SUNDRY NOTICES AND REPORTS ON WELLS (DO NOT USE THIS FORM FOR PROPOSALS TO DRILL OR TO DEEPEN OR PLUG BACK TO A DIFFERENT RESERVOIR. USE "APPLICATION FOR PERMIT" (FORM C-101) FOR SUCH PROPOSALS.)		WELL API NO. 30-015-21819

2. Name of Operator EOG Y Resources, Inc.		6. State Oil & Gas Lease No.
3. Address of Operator 104 South Fourth Street, Artesia, NM 88210		7. Lease Name or Unit Agreement Name Jackson Estate BY

EOG Y Resources, Inc. plans to plug and abandon this well as follows:

WELL NAME: Jackson Estate BY #8 FIELD: \_\_\_\_\_

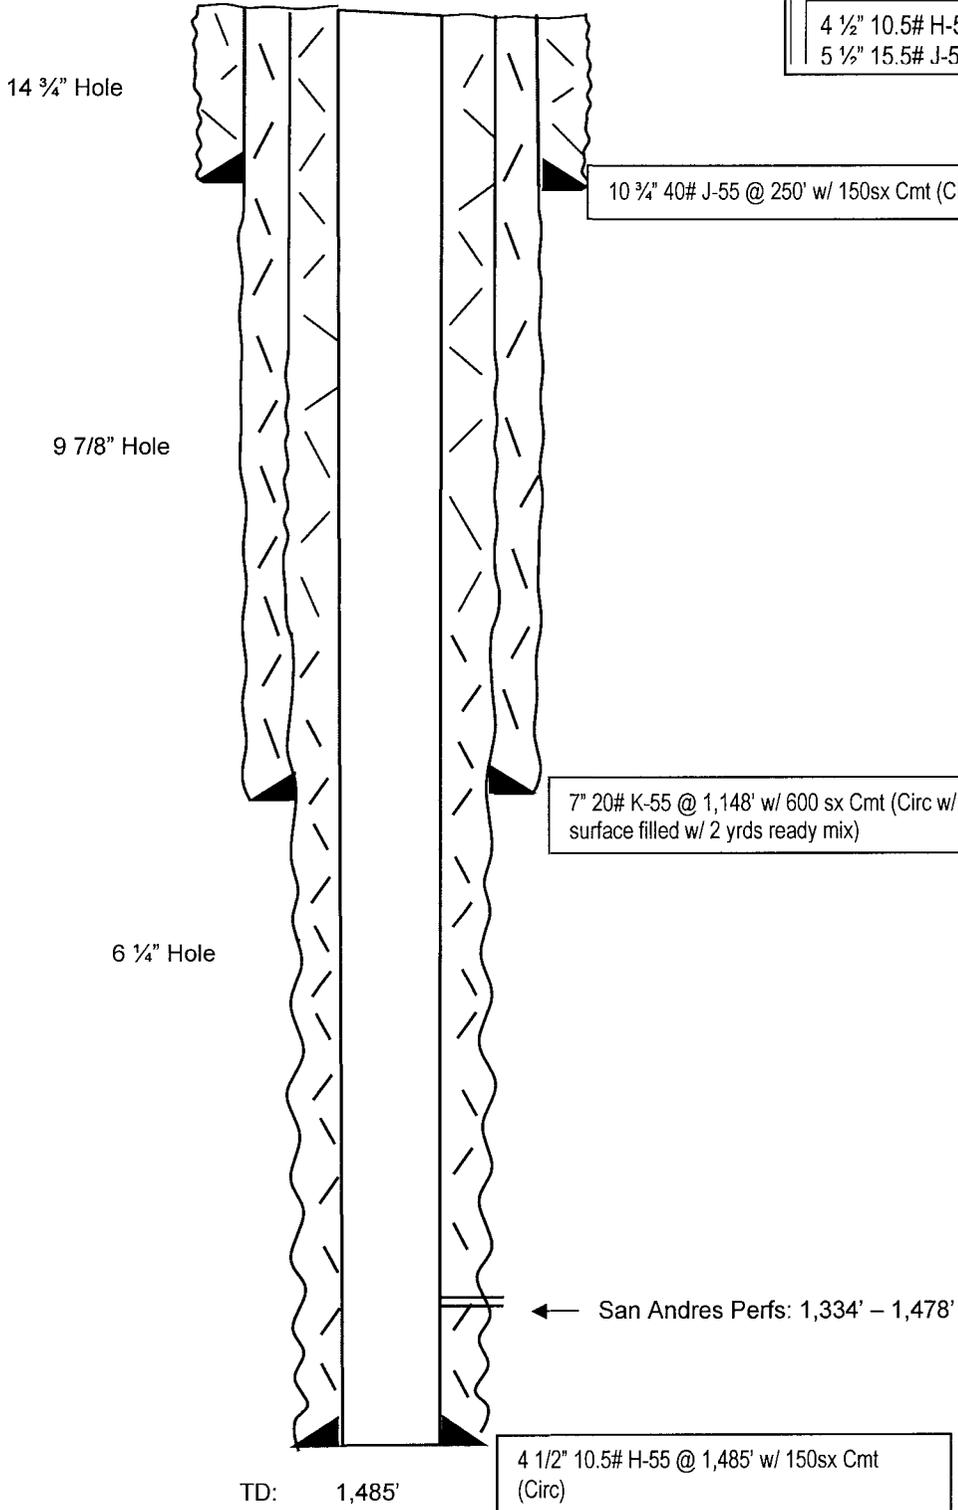
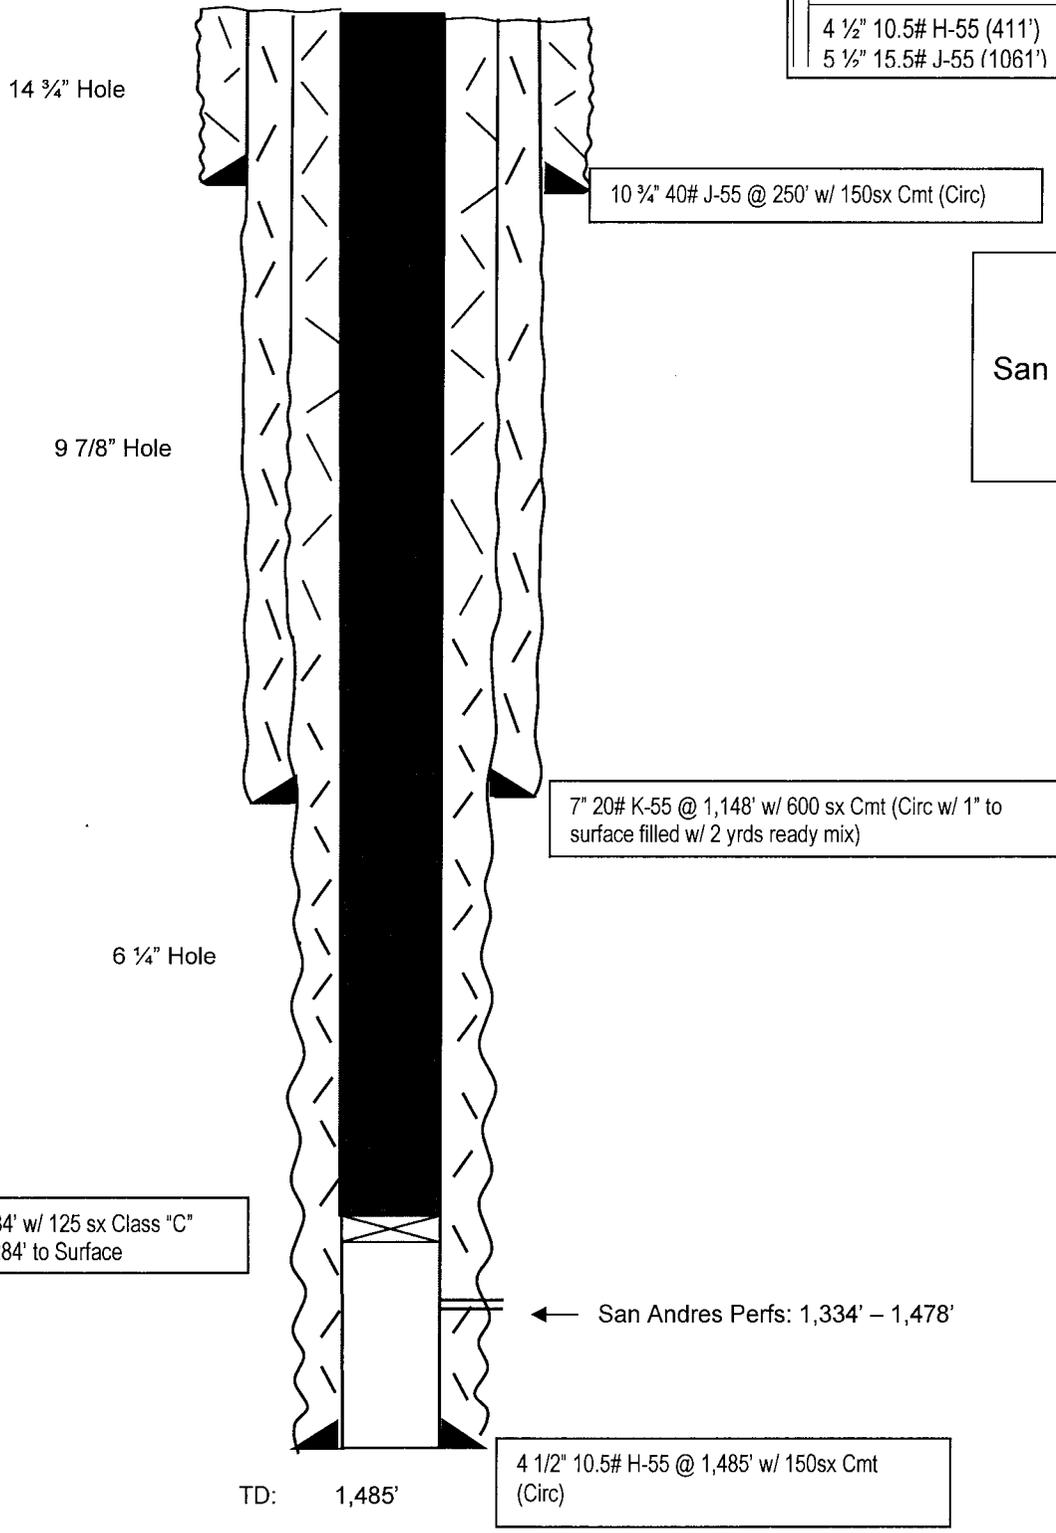
- Notif. NMACD 24 hrs before MIRU*
- MIRU all safety equipment as needed. TOH with production equipment.
  - RIH with GR/JB to 1294'.
  - Set a CIBP at 1284'.
  - Load the hole with fresh water, pressure test 4-1/2" and 5-1/2" casing to 500 psi and circulate a 125 sx Class "C" cement plug from 1284' up to surface. WOC.
  - Back fill as needed.
  - Cut off wellhead, install dry hole marker and clean location.

*\* See Attached COA's Must be Plugged by 2-6-19*
